Site Survey of Selected Items  
for  
Compliance with the Americans with Disabilities Act  
(ADAAG)  
and  
Title 24 of the CBC

The site survey of Ellen Ochoa Learning Center was conducted on February 27, 2007 during a spot check for compliance with the Americans with Disabilities Act Guidelines (ADAAG) and Title 24 of the CBC

# Facility Name: Ellen Ochoa Learning Center

Gate from Florence Avenue Parking to School

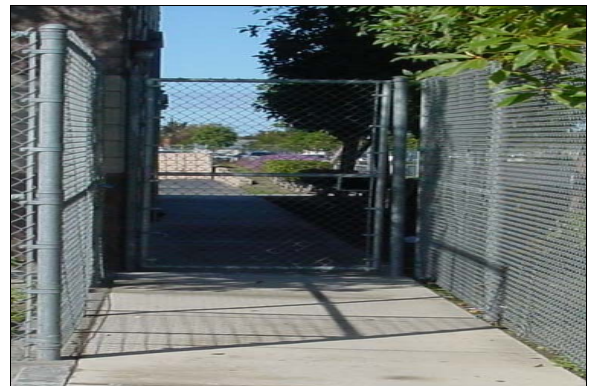
**Finding:** The bottom 10 inches of the gate does not provide a smooth, uninterrupted surface, or panel to allow the door to be opened by a wheelchair footrest without creating a trap or hazardous condition.

**Full Rec** Install a panel or replace the gate to provide a smooth, uninterrupted surface for the bottom 10 inches of the door.

Directional Signage

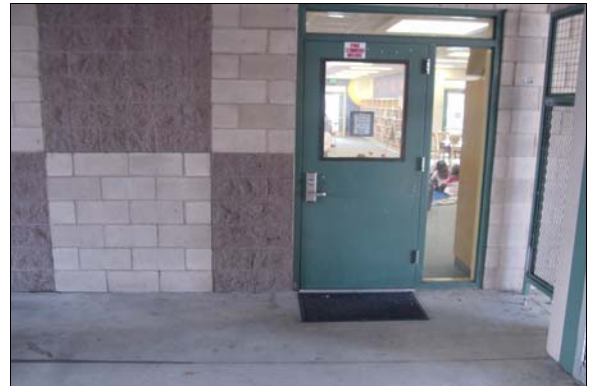
**Finding:** There is no directional signage to the classrooms or other common use areas.

**Full Rec** Install directional signage to each common area complying with CBC 1117B.5 and ADAAG 4.30.

Staff Mens Restroom in the Main Office

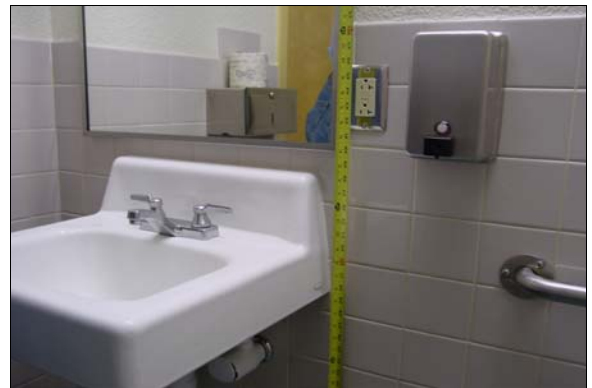
**Finding:** The height of the controls and operating mechanisms for the soap dispenser is greater than 40 inches in height.

**Full Rec** Relocate the soap dispenser to a maximum height of 40 inches for all the controls and operating mechanisms (see CBC 1115B.9.2).
